# DISPUTE REVIEW BOARD RECOMMENDATION

RE: FPN: 231878-1-52-01  
SR-9 (I-95) PBIA from Interchg Southern Blvd. to N. of Belvedere Rd.  
Palm Beach County  
District 4  
Disputes Review Board

Subject: Over Excavation of Material in the Flood Plain Compensation Area

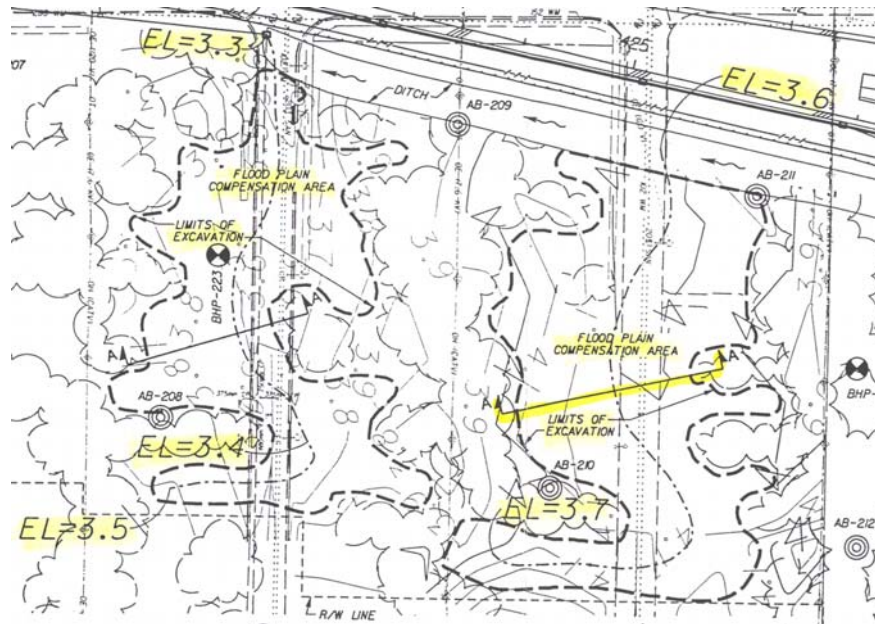
The Contractor's over excavation of this area **voids the calculations** submitted with the permit application **and has created a potential environmental impact.**
- The **Floodplain Compensation Area** is shown in the plans **to be graded to a specific elevation.** (see Exhibit #2) Mining any additional material beyond the limits of those set elevations is not in accordance with the contract. **All material below the final elevation grades given in the plans is material owned by the state and the Contractor has no right of ownership of that material.**

- Sheet 116 of the plans indicates the limits of excavation within the Flood Plain Compensation.

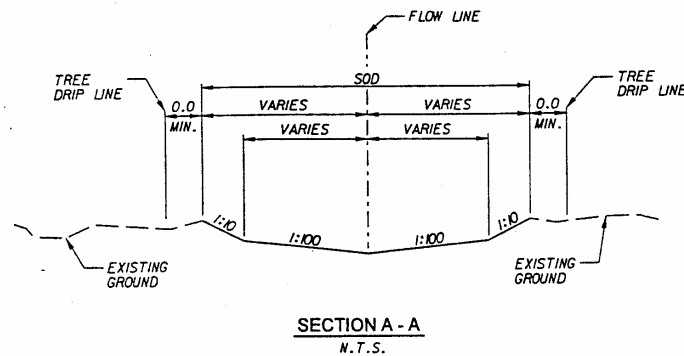
- Section A-A further defines the configuration.

- The temporary over excavation by the contractor is mostly outside of the limits of excavation shown on the plans.
- The note on sheet 116 alerts the reader that this is a sensitive area.

- It was acknowledged by the Department in the DRB hearing that this note was a hold-over from previous design considerations and should have been removed prior to bid.
